Accessibility Survey

City of Downey Lindsey Avenue - Cedartree Road to Brookpark Road

Date of Inspection 6/14/2017

Change in Level South of Cedartree Road @ 33.954887583451, -118.106785118580

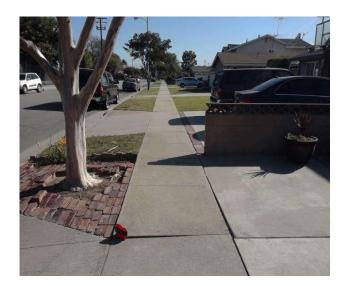
There is a change in elevation greater than recommended value.

On-Site Finding 0.62 inches

Ensure that the change in elevation is within the recommended value.

Recommendation Up to 0.25 inches

Change in Level South of Cedartree Road @ 33.954902044859, -118.106778413057

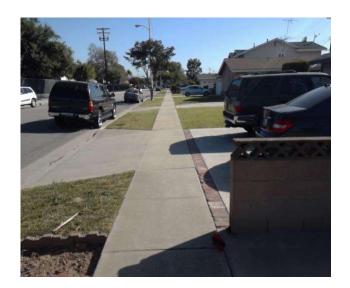
There is a change in elevation greater than recommended value.

On-Site Finding 0.62 inches

Ensure that the change in elevation is within the recommended value.

Recommendation Up to 0.25 inches

Driveway North of Cedartree Road @ 33.955080031227, -118.106874972582

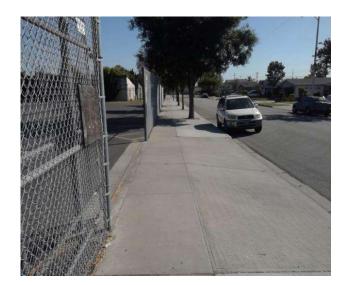
There are no detectable warnings where the pedestrian route crosses vehicular traffic.

On-Site Finding Not Found

Provide detectable warnings.
